## **ENTERPRISE SUBDIVISION**

Engineering Comments: FINAL PLAT COMMENTS (should be addressed prior to submitting the FINAL PLAT for review and/or signature by the City Engineer):

APPLICATION NUMBER 1 DATE July 6, 2017

REQUEST Subdivision

# DETAIL SITE PLAN

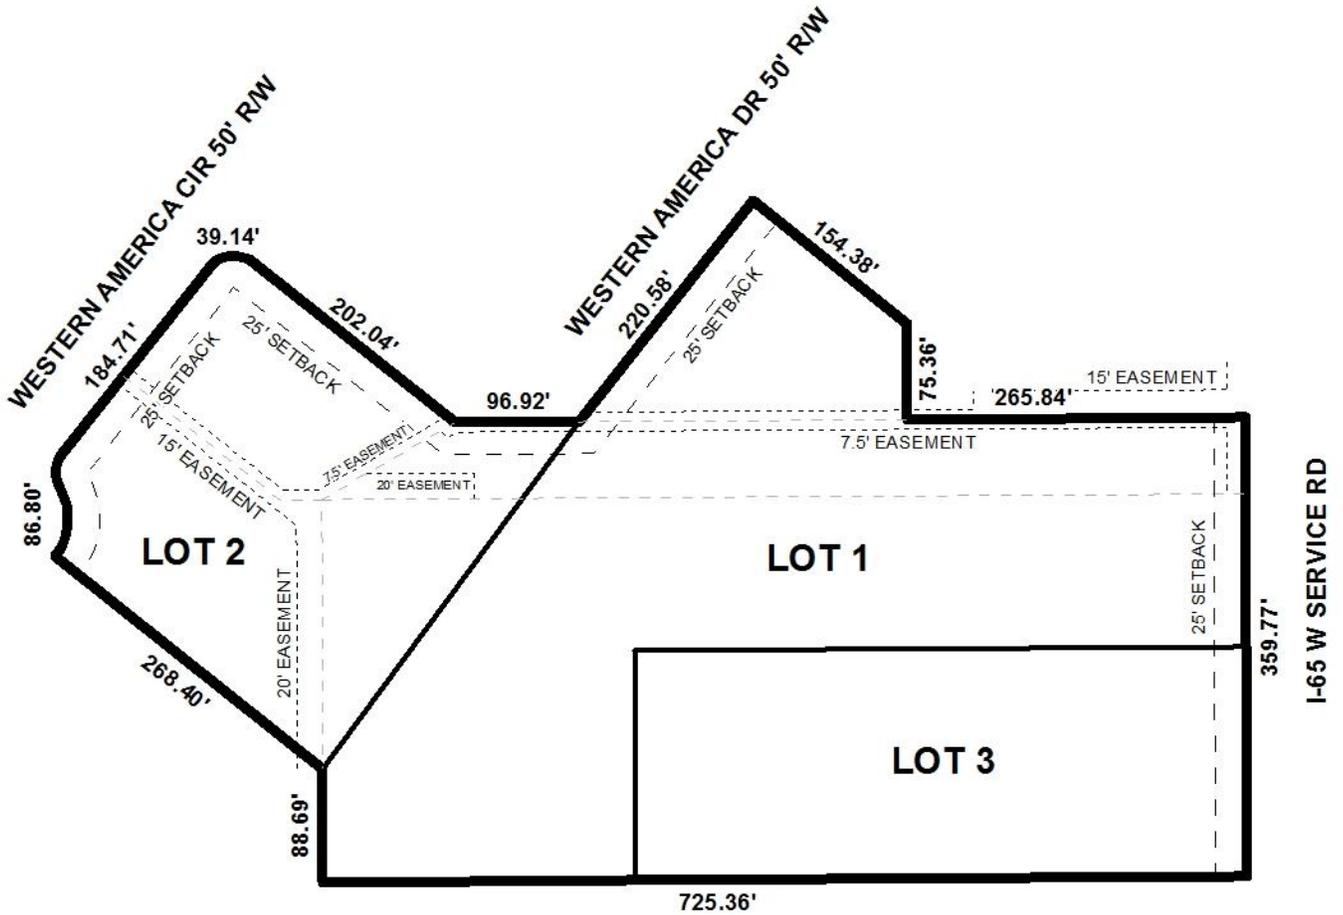
*The plat now illustrates the proposed 3-lot, 8.0± acres subdivision located on the West side of West I-65 Service Road South, 533'± South of Western America Drive, in Council District 5. The applicant states the property is served by public water and sewer.*

*Proposed Lot 3 has 180'± of frontage on West I-65 Service Road South, to the East, an ALDOT-maintained limited access route with a 300' right-of-way width. An adequate right-of-way is illustrated on the preliminary plat; therefore, no additional dedication should be required.*

*It should be noted that the widths of the portions of proposed Lot 3 along which it has frontage is large enough to be potentially re-subdivided and, in accordance with Section V.D.3. of the Subdivision Regulations, is not exclusive of unusable land thus contributing to a depth more than 3.5 times its widths at its potential building setbacks. Planning Commission approval of similar lots in the vicinity of the subject site may facilitate approval of this request, but will require a waiver of Section V.D.3. of the Subdivision Regulations. Also, if approved, a note should be required on the Final Plat stating further re-subdivision of Lot 3 will not be allowed until additional public street frontage is provided.*

*Irrespective of the width-to-depth ratio Lot 3 satisfies the minimum size requirements for lots served by public water and sanitary sewer, and is appropriately labeled on the preliminary plat. The 25' minimum building setback line is also illustrated along West I-65 Service Road South. This information should be retained on the Final Plat, or a table providing the same information should be provided, if approved.*

*With regards to access management, a note should be required on the Final Plat stating Lot 3 is limited to no more than one curb cut to West I-65 Service Road South, with any changes in its*

size, location, or design to be approved by ALDOT and Traffic Engineering, and conform to AASHTO standards.

Finally, it should be noted that, per Traffic Engineering comments, shared access between proposed Lots 1 and 3 may be required based on ALDOT access management practices. The applicant should be aware that such shared access would require the approval of a Planned Unit Development by the Planning Commission.

Based on the preceding, with waivers of Sections V.D.1. and V.D.3, the plat is recommended for Tentative Approval subject to the following conditions:

- 1) placement of a note on the Final Plat stating further subdivision of Lots 1 and 3 will not be allowed until additional public street frontage is provided;

- 2) retention of the all lot sizes in square feet and acres on the Final Plat, or provision of a table providing the same information;
- 3) placement of a note stating that Lot 1 is limited to one curb cut to Western America Drive and no more than one curb cut to West I-65 Service Road South, Lot 2 is limited to one curb cut to Western America Drive and one curb cut to Western America Circle, and Lot 3 is limited to no more than one curb cut to West I-65 Service Road South, with any changes in their sizes, locations, or designs to be approved by ALDOT (where applicable) and Traffic Engineering, and conform to AASHTO standards;

- 4) placement of a note on the Final Plat stating no structures shall be constructed in any easement;
- 5) compliance with Engineering comments: (FINAL PLAT COMMENTS (should be addressed prior to submitting the FINAL PLAT for review and/or signature by the City Engineer): A) Provide all of the required information on the SUBDIVISION PLAT (i.e. signature blocks, signatures, certification statements, written legal description, required notes, legend, scale, bearings and distances) that is required by the current Alabama State Board of Licensure for Professional Engineers and Land Surveyors. B) Add legible street names to the vicinity map. C) Label the information for the adjoining lots to the south. The proposed lot SE of LOT 1 (180' x 480') should also be labeled. D) Provide and label the monument set or found at each subdivision corner. E) Add a signature block for the Owner, Notary Public, Planning Commission, Traffic Engineer, and City Engineer. F) Provide the Surveyor's Certificate and Signature. G) Provide the Surveyor's, Owner's (notarized), Planning Commission, and Traffic Engineering signatures. H) Add a note to the SUBDIVISION PLAT stating that a Land Disturbance permit will be required for any land disturbing activity in accordance with Mobile City Code, Chapter 17, Storm Water Management and Flood Control); the City of Mobile, Alabama Flood Plain Management Plan (1984); and, the Rules For Erosion and Sedimentation Control and Storm Water Runoff Control. I) Add a note to the Plat stating that the approval of all applicable federal, state, and local agencies (including all storm water runoff, wetland and floodplain requirements) will be required prior to the issuance of a Land Disturbance permit. J) Add a note that sidewalk is required to be constructed, and/or repaired, along the frontage of each lot, or parcel, at time of new development or construction, unless a sidewalk waiver is approved. K) Provide a copy of the FINAL SUBDIVISION PLAT to the Engineering Dept. for review. No signatures are required on
